Project	<b>IEEE 802.16 Broadband Wireless Access Working Group</b> < <a href="http://ieee802.org/16">http://ieee802.org/16</a> >	
Title	Clarification on UL CQICH SNR feedback for MIMO systems	
Date Submitted	<b>2005-03-15</b>	
Source(s)	Jianzhong (Charlie) Zhang, Anthony Reid, Kiran Kuchi, Heikki Berg, Nico Van Waes  Nokia Research Center 6000 Connection Drive Irving, TX 75039	Voice: 972-374-0958 Fax: 972-894-5937 <a href="mailto:charlie.zhang@nokia.com">charlie.zhang@nokia.com</a>
Re:	IEEE 802.16e D5 Draft	
Abstract	Proposes an improved channel quality indicator for vertically encoded MIMO systems	
Purpose	To incorporate the changes proposed here into the 802.16e D6 Draft.	
Notice	This document has been prepared to assist IEEE 802.16. It is offered as a basis for discussion and is not binding on the contributing individual(s) or organization(s). The material in this document is subject to change in form and content after further study. The contributor(s) reserve(s) the right to add, amend or withdraw material contained herein.

# UL CQICH SNR Feedback for MIMO Systems

Figure 229b – Post Processed S/N for MIMO

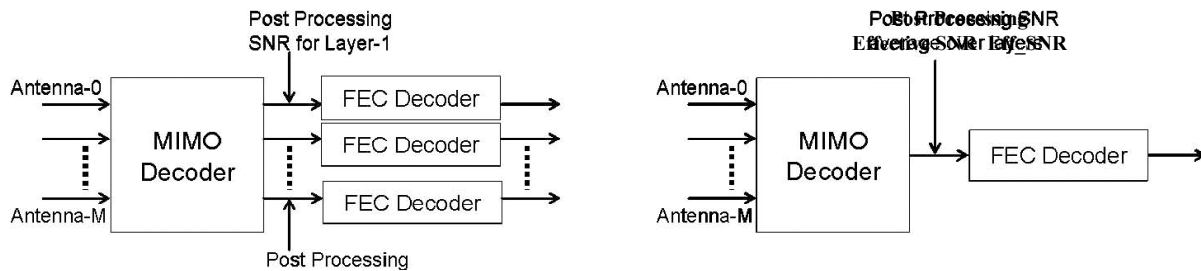
MIMO capable MS shall measure post processing S/N for each individual layers as shown in Figure 229b. When the FAST\_FEEDBACK subheader Feedback Type field is “00”, the MS shall report the post

processing Effective SNR (Eff\_SNR) as defined below. When BS requests MS feedback through CQICH\_Alloc\_IE() or CQICH\_Enhanced\_Alloc\_IE() with '00' Feedback\_type field, MS shall report Eff\_SNR or individual layer S/N as described in 8.4.5.4.12 and 8.4.5.4.15

Note that the effective SNR (Eff\_SNR) is defined as

where  $C(d,y|H)$  is the receiver-constrained mutual information conditioned on knowing the channel knowledge. Note that  $d$  is the transmitted signal,  $y$  is the post-processing receive signal and  $H$  is the channel matrix between transmit and receive antennas. For LMMSE-type of MIMO detectors where individual post-detector-processing signal to noise ratios are given as  $SNR_1, \dots, SNR_N$ , then the average receiver-constrained mutual information is given by

on the other hand, for ML MIMO detectors the receiver-constrained mutual information is simply the MIMO channel mutual information:

where  $I_N$  is an  $N$  by  $N$  identity matrix and  $R$  is the correlation matrix of interference plus noise measured at SS. Once receiver-constrained mutual information is obtained from (b) or (c), equation (a) is used to calculate the Eff\_SNR for a vertically encoded system.
